CCB Review cum PCN Workbook

PCN Workbook

PCN - 14 062

Product Name:	USB2.0 Right Up type			
	Shell of USB2.0			
Product Manager:	Otto.Yang			
Subject:	Notification of Change with Immediate Effectivity			
Distribution:	General			
Type of Change:	Process Change			
Change Description:	Change Tin plating finish on legs area from bright to matte type

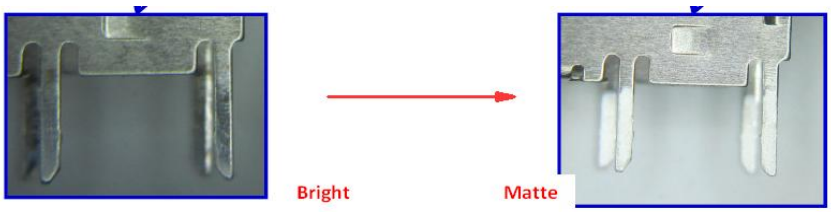
Reason for Change:	Due to current supplier's process adjustment and capability limits , they can only make matte finish Tin for this product, change is only in plating surface texure on the legs area (from bright to matte) and so has no functional impact.			
Affected Parts:	73725-0020BLF/ 73725-0120BLF/ 73725-1020BLF/ 73725-1120BLF			
Effective Date of Change:	January 30, 2015			
Last Time Buy Date:	NA			
Last Disty Return Date:	NA			
Last Time Shipment Date	NA			
Datasheet Attached?	Yes			
Qual/Test Data Attached?	NA			
Samples Availability Date:	July	21	2014	
Available Alternatives?	N/A			
Questions?	*Contact your local FCI Representative, or Product Manager*
